RE: **DOCKET NO. 508** – The United Illuminating Company (UI) Certificate of Environmental Compatibility and Public Need for the Milvon to West River Railroad Transmission Line 115-kV Rebuild Project that consists of the relocation and rebuild of its existing 115- kilovolt (kV) electric transmission lines from the railroad catenary structures to new steel monopole structures and related modifications to facilitate interconnection of the rebuilt 115-kV electric transmission lines at UI's existing Milvon, Woodmont, Allings Crossing, Elmwest and West River substations along approximately 9.5 miles of the Connecticut Department of Transportation's Metro-North Railroad corridor traversing the municipalities of Milford, Orange, West Haven and New Haven, Connecticut.
Partial Development and Management (D&M) Plan - Segment 3 Revision.

Re: Docket No. 508 - The United Illuminating Company Application for a Certificate of Environmental Compatibility and Public Need for the Milvon to West River Railroad Transmission Line 115-kV Rebuild Project – Request for Modification to Segment 3 (Woodmont Substation to Allings Crossing Substation) Development and Management Plan

UI 115-kV RR PROJECT MILV

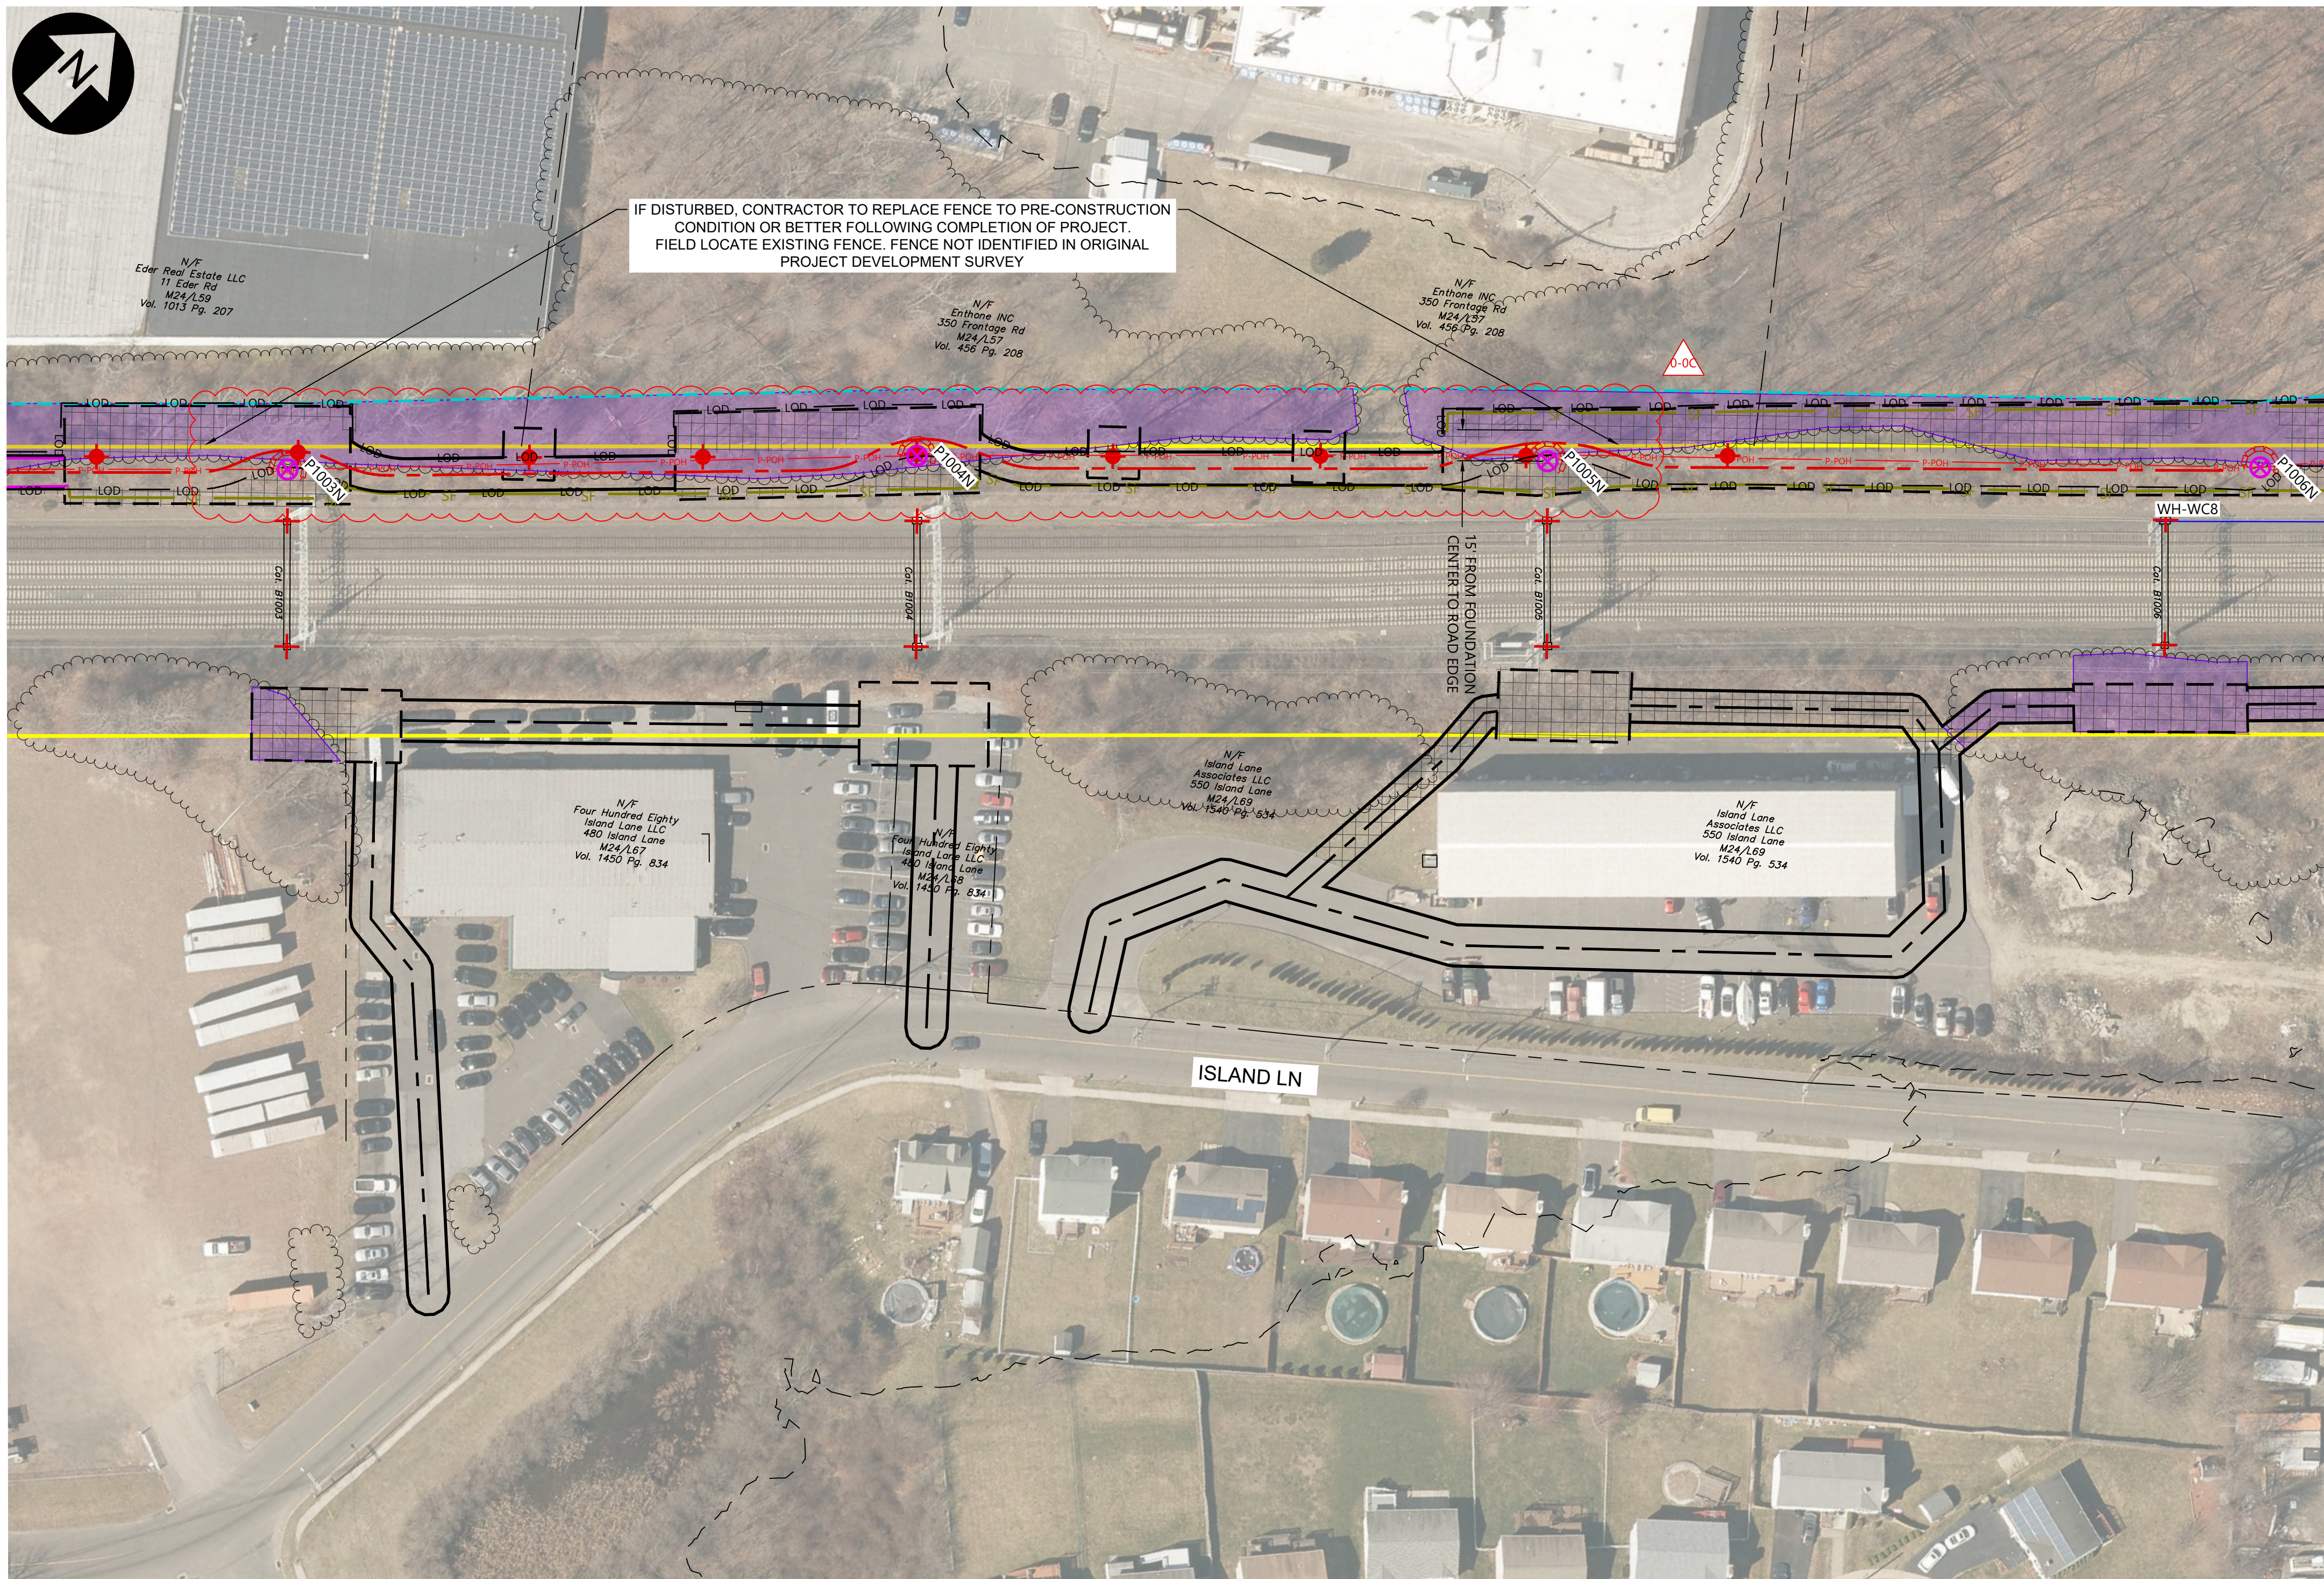
- a) Relocate Structure P1005N approximately 3 feet southeast;
- b) Relocate the permanent access road to the southeast in the vicinity of Structures 1003N through 1005N; and
- c) Reduce the access road width to approximately 12 feet in the vicinity of Structure 1004N.

Pursuant to the Regulations of Connecticut State Agencies Section 16-50j-62(b)(2) and Attachment M to the Development & Management (D&M) Plan (approved June 8, 2023), The United Illuminating Company (“UI”) is hereby requesting a modification from the Connecticut Siting Council (the “Council”). The modification is associated with the relocation of transmission line pole P1005N.

To reduce impacts on an adjoining property and to allow for the reestablishment of a fence line in accordance with a property easement, UI has identified the need to shift structure P1005N, which is located within the planned permanent roadway between structures P1003N and P1005N in Milford, CT. UI respectfully requests the shifting of structure P1005N and the associated permanent road. If approved, structure P1005N will be shifted approximately 3’ southeast. The permanent road would be adjusted around structures P1004N and P1005N and decreased to approximately 12’ around P1004N. These shifts will not affect LOD or clearing.
